Maryland Zoo in Baltimore Red Panda  
Responses to Bidder Questions and Written Identification of Modifications to Project Documents

**BULLETIN NO. 3**

**Responses to Bidder Questions:**

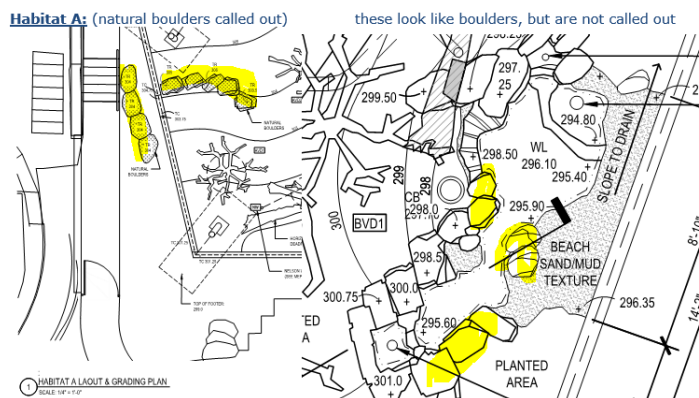
- Vertical & Horizontal Deadfall - there's a note saying, where possible, existing trees removed from project site to be used as deadfall inside of the enclosures. Please confirm that all trees will be salvaged on site.

The design team cannot confirm this. Use trees from the site where/when they meet size and configuration requirements.
